## PRODUCT CHANGE NOTIFICATION (PCN)

### A-MCSP-80010/Y MODULAR CABLE

CHANGE NOTIFICATION: PCN 20220425\_A-MCSP-80010/Y

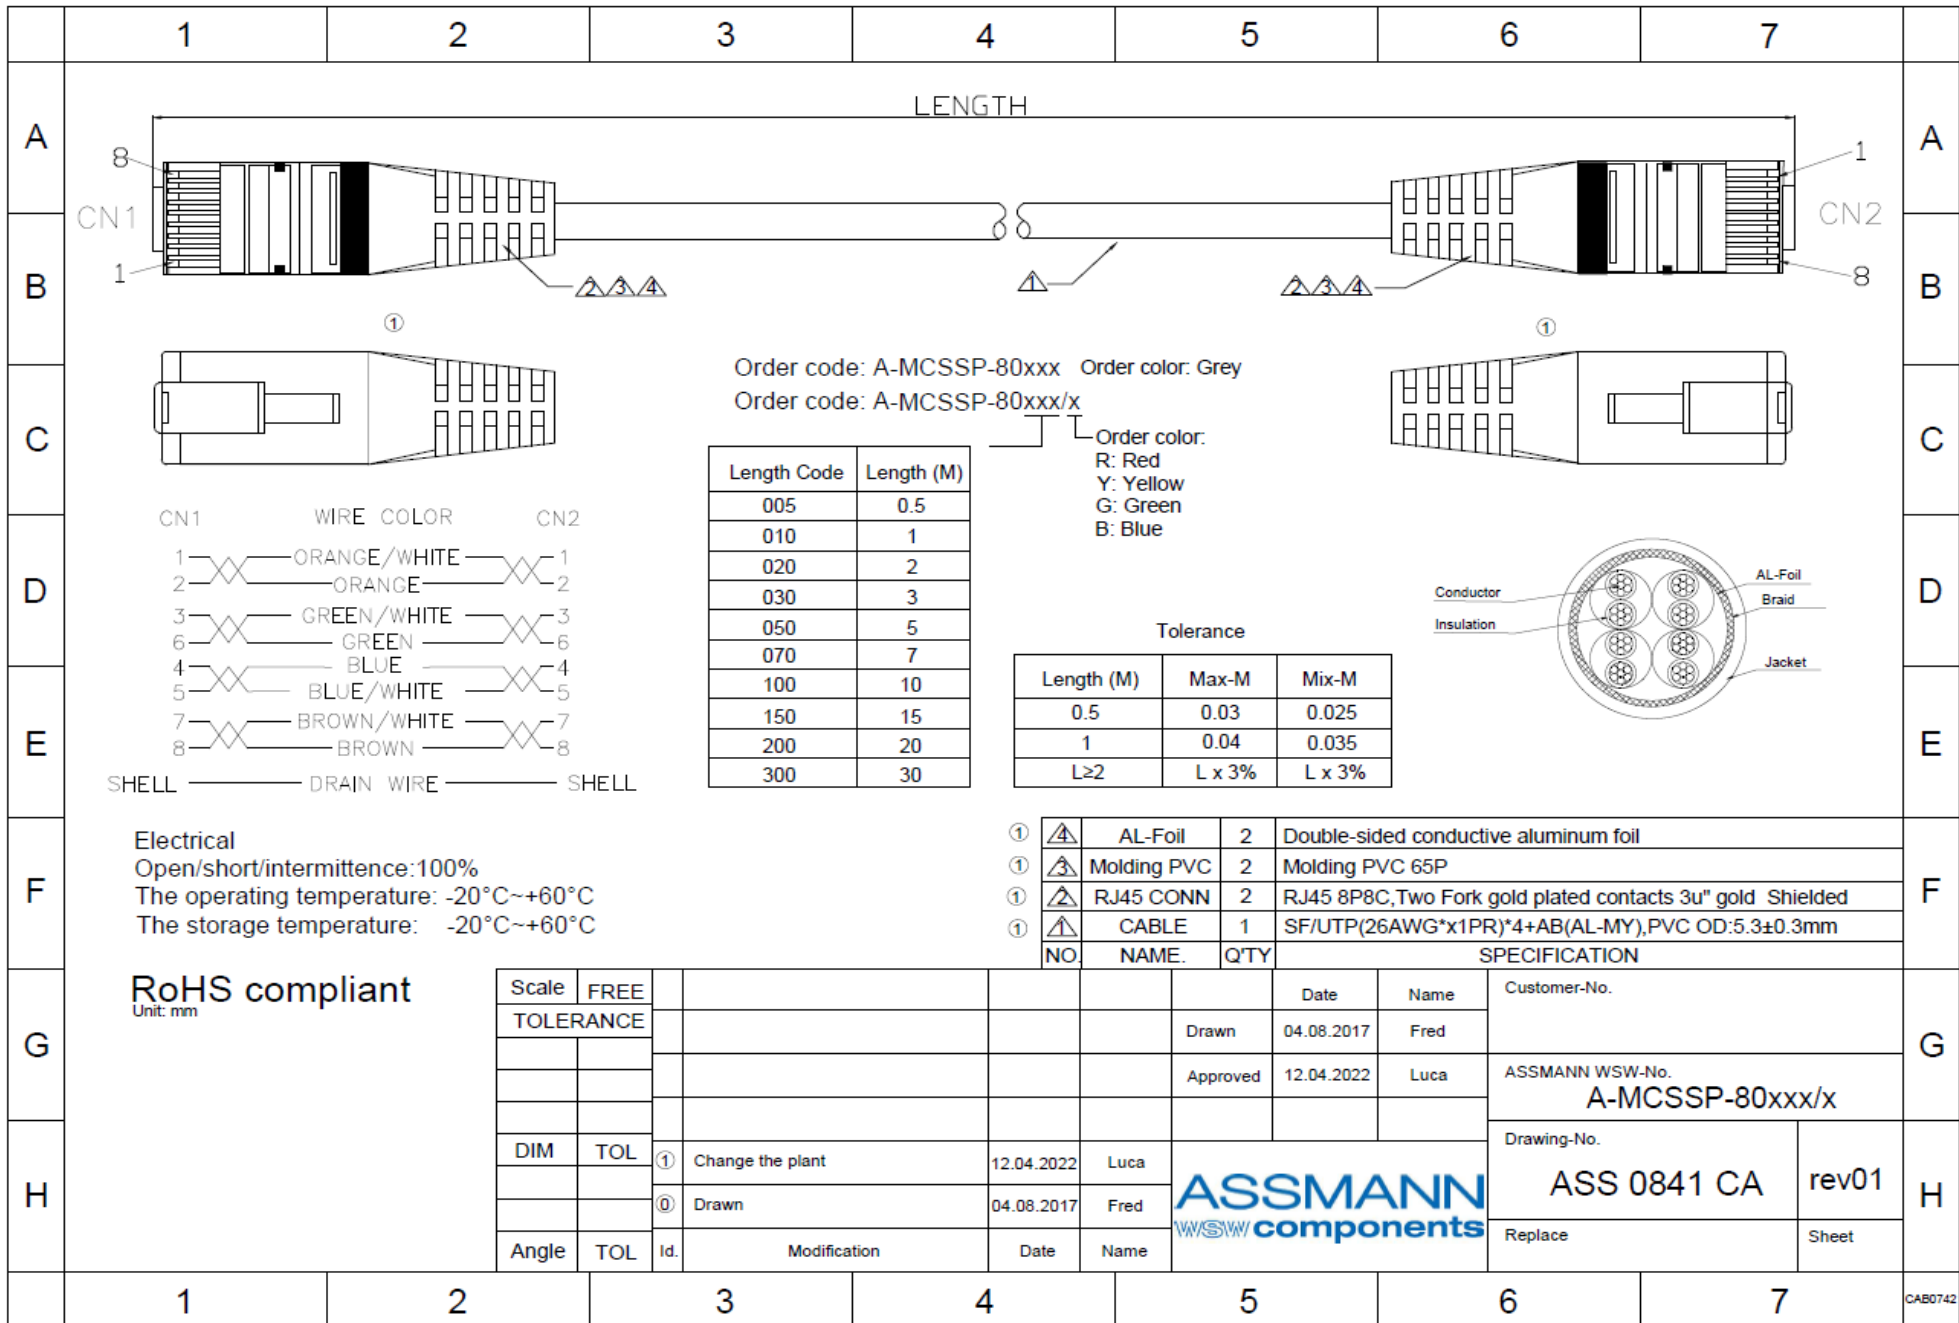
DESCRIPTION OF CHANGES: CHANGE OF DATA SHEET  
CHANGE OF DATA SHEET  
New Draw.-No. ASS\_0841\_CArev01

REASON FOR CHANGE: CHANGE OF PRODUCT LOCATION  
CHANGE OF PRODUCT LOCATION

A-MCSP-80010/Y	OLD VERSION	A-MCSP-80010/Y	NEW VERSION																																				
<p>Appearance</p>		<p>Appearance</p>																																					
<p>BOM</p> <table border="1"> <thead> <tr> <th>NO.</th> <th>NAME.</th> <th>Q'TY</th> <th>SPECIFICATION</th> </tr> </thead> <tbody> <tr> <td>③</td> <td>Molding PVC</td> <td>2</td> <td>Molding PVC 45P</td> </tr> <tr> <td>②</td> <td>RJ45 CONN</td> <td>2</td> <td>RJ45 8P8C,Two Fork gold plated contacts 3u" gold</td> </tr> <tr> <td>①</td> <td>CABLE</td> <td>1</td> <td>SFTP(26AWG*x1PR)*4+AB,PVC OD:5.3±0.3mm</td> </tr> </tbody> </table>		NO.	NAME.	Q'TY	SPECIFICATION	③	Molding PVC	2	Molding PVC 45P	②	RJ45 CONN	2	RJ45 8P8C,Two Fork gold plated contacts 3u" gold	①	CABLE	1	SFTP(26AWG*x1PR)*4+AB,PVC OD:5.3±0.3mm	<p>BOM</p> <table border="1"> <thead> <tr> <th>NO.</th> <th>NAME.</th> <th>Q'TY</th> <th>SPECIFICATION</th> </tr> </thead> <tbody> <tr> <td>①</td> <td>AL-Foil</td> <td>2</td> <td>Double-sided conductive aluminum foil</td> </tr> <tr> <td>①</td> <td>Molding PVC</td> <td>2</td> <td>Molding PVC 65P</td> </tr> <tr> <td>①</td> <td>RJ45 CONN</td> <td>2</td> <td>RJ45 8P8C,Two Fork gold plated contacts 3u" gold Shielded</td> </tr> <tr> <td>①</td> <td>CABLE</td> <td>1</td> <td>SF/UTP(26AWG*x1PR)*4+AB(AL-MY),PVC OD:5.3±0.3mm</td> </tr> </tbody> </table>		NO.	NAME.	Q'TY	SPECIFICATION	①	AL-Foil	2	Double-sided conductive aluminum foil	①	Molding PVC	2	Molding PVC 65P	①	RJ45 CONN	2	RJ45 8P8C,Two Fork gold plated contacts 3u" gold Shielded	①	CABLE	1	SF/UTP(26AWG*x1PR)*4+AB(AL-MY),PVC OD:5.3±0.3mm

NO.	NAME.	Q'TY	SPECIFICATION																																				
③	Molding PVC	2	Molding PVC 45P																																				
②	RJ45 CONN	2	RJ45 8P8C,Two Fork gold plated contacts 3u" gold																																				
①	CABLE	1	SFTP(26AWG*x1PR)*4+AB,PVC OD:5.3±0.3mm																																				
NO.	NAME.	Q'TY	SPECIFICATION																																				
①	AL-Foil	2	Double-sided conductive aluminum foil																																				
①	Molding PVC	2	Molding PVC 65P																																				
①	RJ45 CONN	2	RJ45 8P8C,Two Fork gold plated contacts 3u" gold Shielded																																				
①	CABLE	1	SF/UTP(26AWG*x1PR)*4+AB(AL-MY),PVC OD:5.3±0.3mm																																				
<p>FOR DETAIL, PLEASE TAKE ATTACHED NEW DRAWING: FOR REFERENCE</p>
